Plat of Samish Heights
Skagit County, Washington

Stormwater and Drainage Facilities Maintenance Manual

RE: Addendum to Blanchard Knob and Samish heights stormwater design

Dispersion Proposal

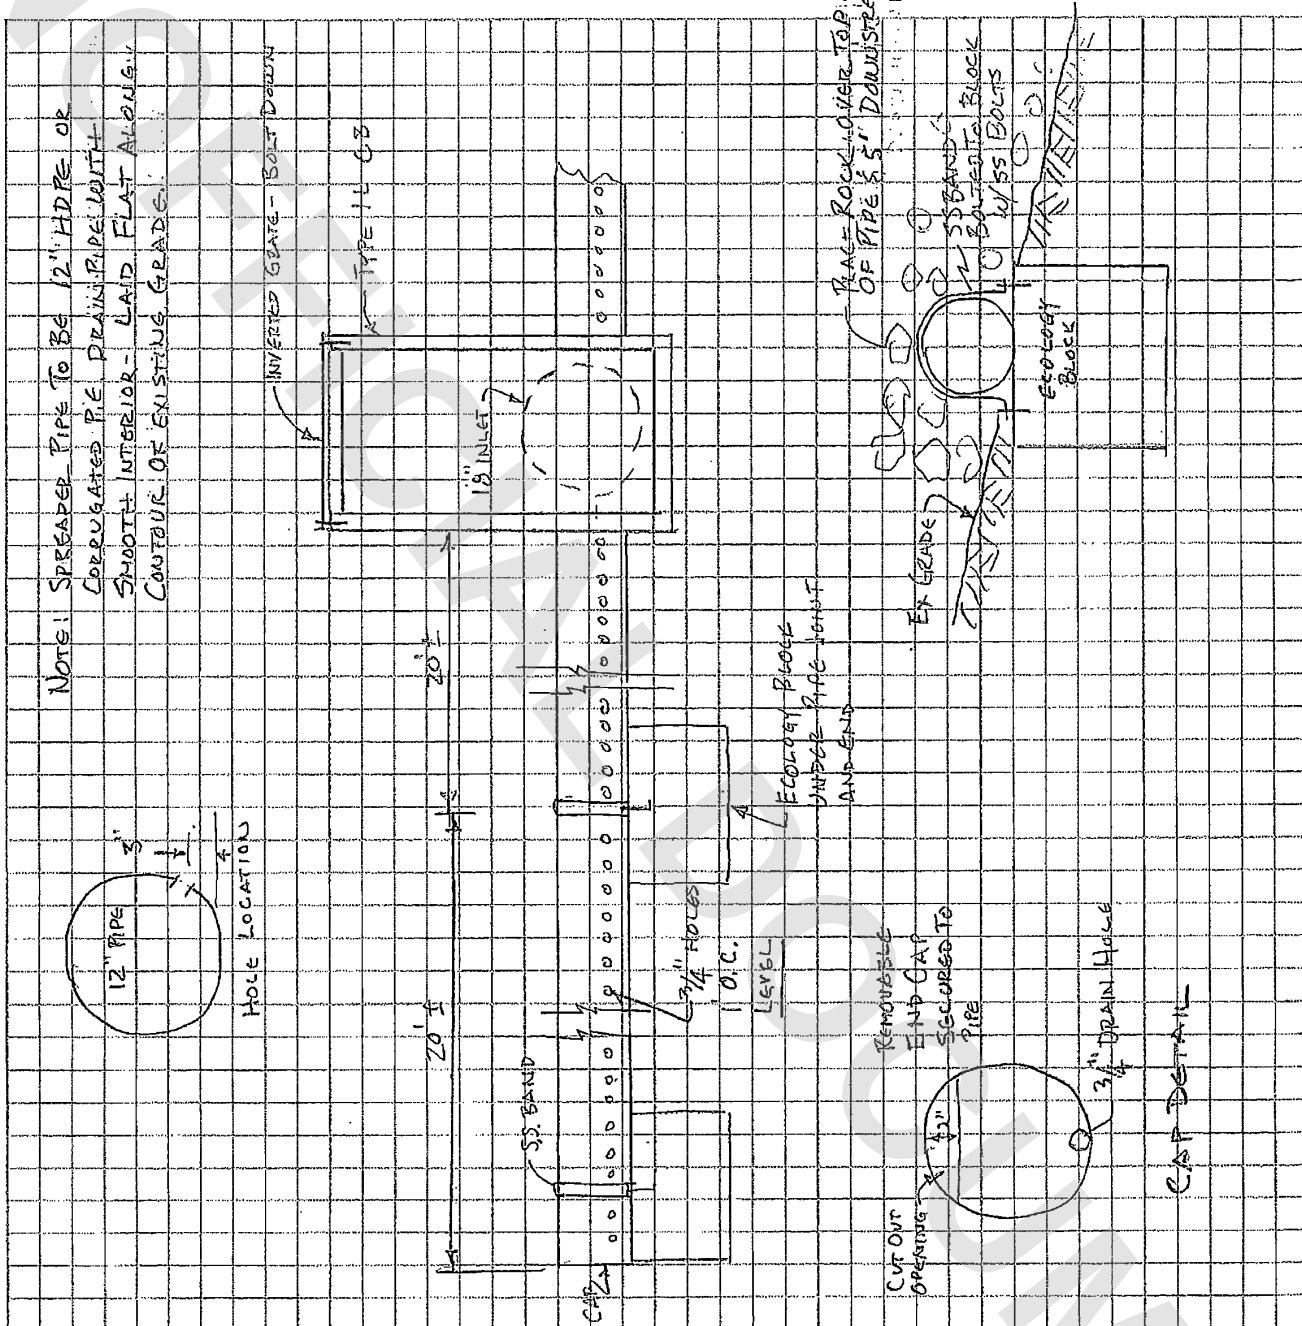
*Monitor dispersion from this
spreader during significant rain
events & through the next
wet season for any re-concentrated
flows within 100'. Additional
measures can be performed as
needed.*

*Follow up inspection req'd
5-15-18*
